## HISTORIC AND DESIGN REVIEW COMMISSION

**HDRC CASE NO:** 2019-101  
**ADDRESS:** 802 NOLAN  
**LEGAL DESCRIPTION:** NCB 563 BLK 7 LOT W102.6 FT OF 1 AT 802 NOLAN  
**ZONING:** R-6, H  
**CITY COUNCIL DIST.:** 2  
**DISTRICT:** Dignowity Hill Historic District  
**OWNER:** Paula and William O'Neal  
**TYPE OF WORK:** Amendment to the previously approved design regarding fenestration and accessory structure setbacks  
**APPLICATION RECEIVED:** February 26, 2019  
**60-DAY REVIEW:** April 27, 2019

The applicant is requesting a Certificate of Appropriateness for approval to amend the previously approved design regarding the following items:

SITE PLAN

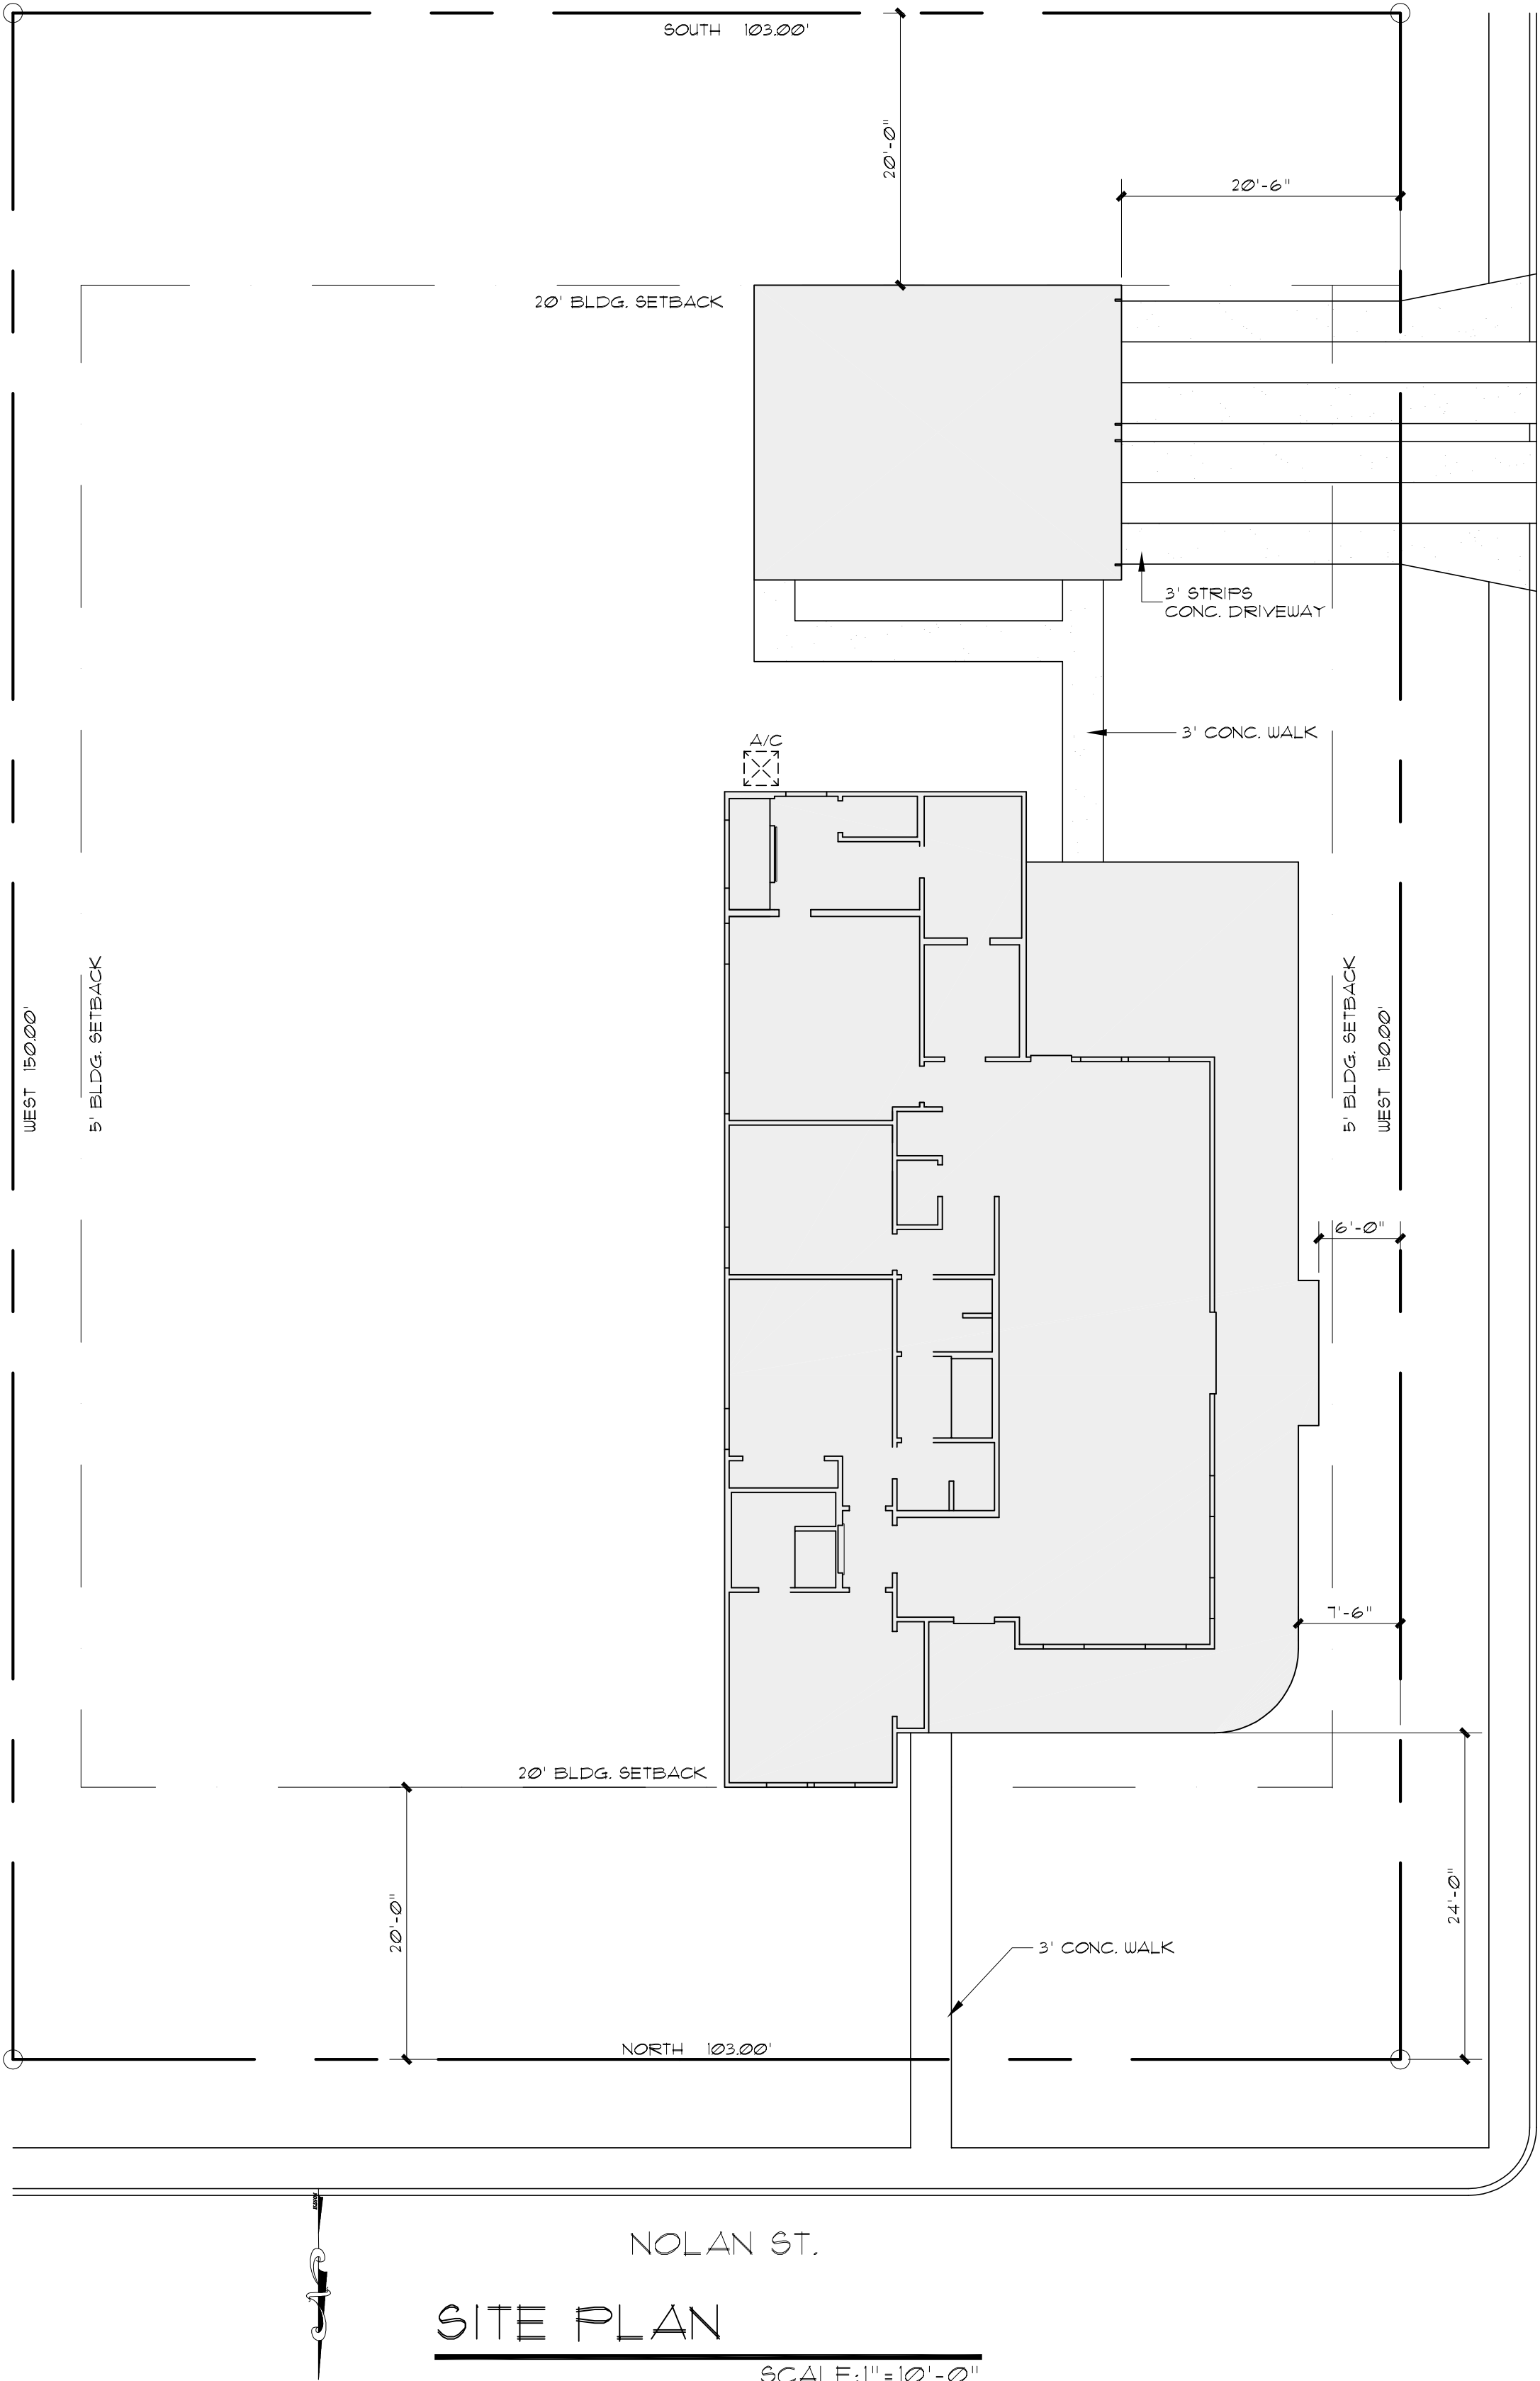
- c. GARAGE SETBACK – The applicant has noted due to site constraints that the proposed, detached rear accessory structure cannot feature an increased setback on the west side of the property. The proposed new construction is to feature a setback of approximately seven (7) feet from the property line on N Olive. The proposed setback for the rear accessory structure is approximately twenty (20) feet from the property line on N Olive. The historic structure to the immediate south features a setback of approximately forty-five (45) feet from the street. Staff finds that while the proposed accessory structure does not feature a setback greater than that of the neighboring historic structure, it does feature a setback that is greater than that of the primary structure on the lot.

LEFT ELEVATION  
SCALE: 3/16" = 1'-0"

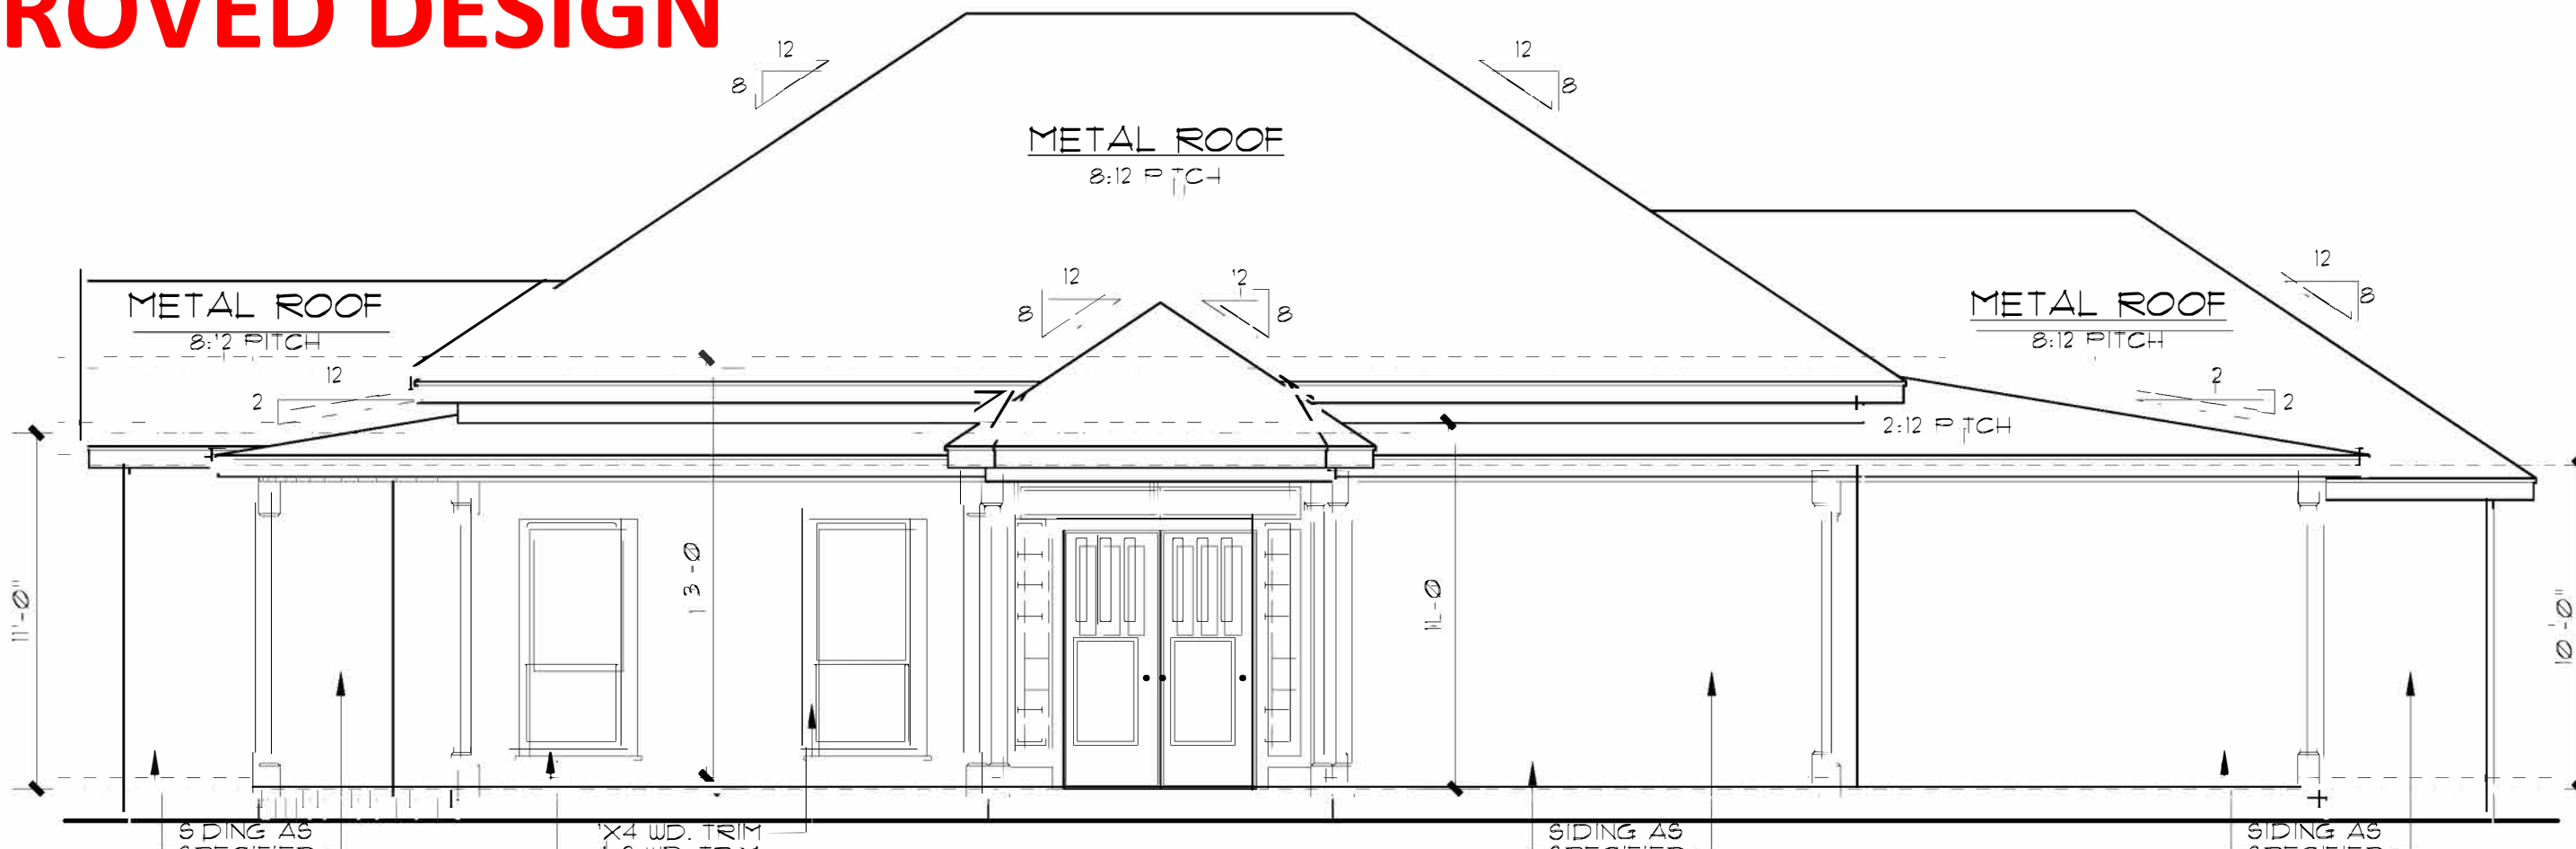
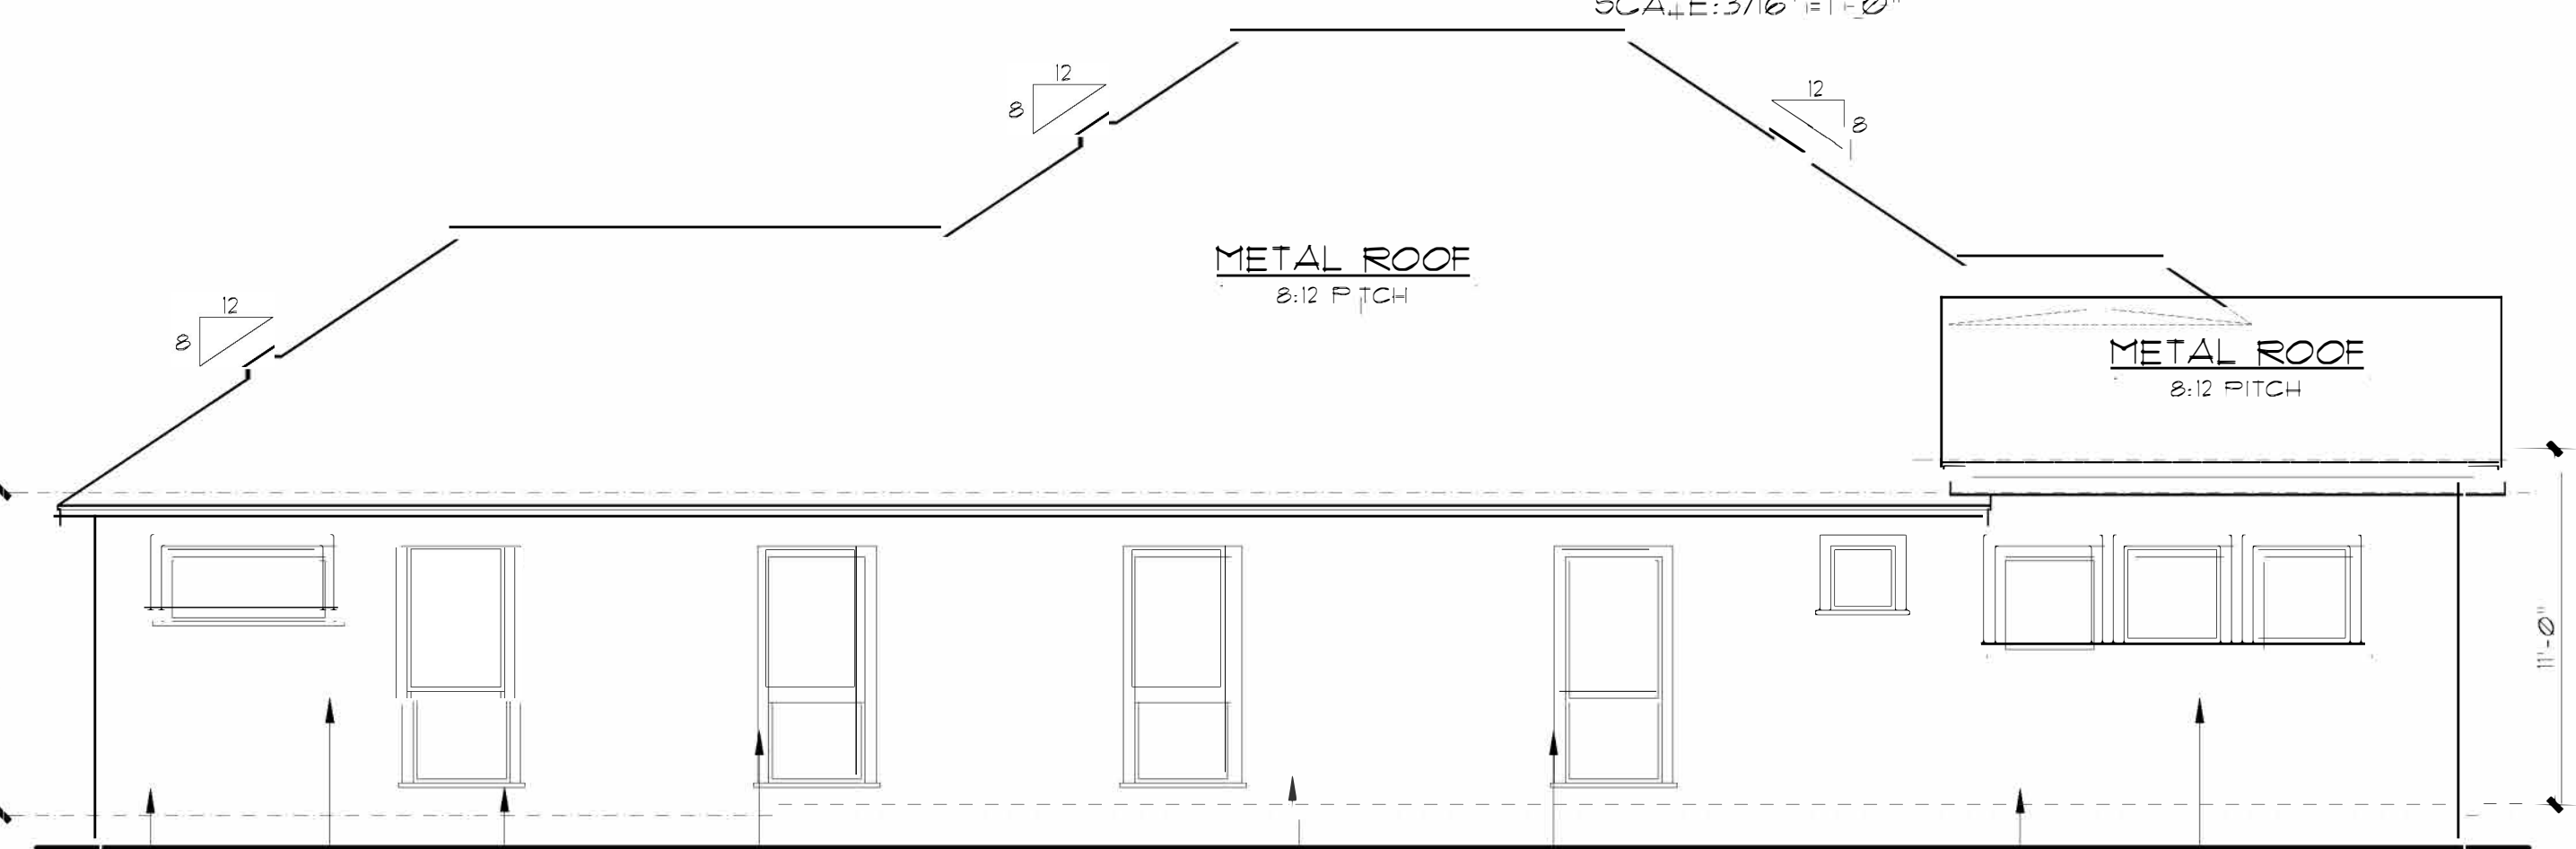
- b. FENESTRATION – The applicant has proposed to construct the proposed new construction with no window fenestration toward the rear of the proposed new construction. The location that the applicant has proposed to not feature fenestration is to the immediate right of a side entrance. The applicant has noted that due to interior layouts, additional fenestration cannot be added. Staff finds that fenestration at locations to the rear of the side entrance should be included. The use of a faux window installed in front of a furr wall, a faux window with functional shutters with traditional profiles, or windows of smaller proportions may be used.

1. Staff does not recommend approval of item #1. Staff recommends that fenestration at locations to the rear of the side entrance should be included. The use of a faux window installed in front of a furr wall, a faux window with functional shutters with traditional profiles, or windows of smaller proportions may be used.
2. Staff recommends approval of item #2 with the stipulation that the profile of the apron be traditional and transform to two, separate sets of ribbon strips. The ribbon strips should feature a uniform apron.
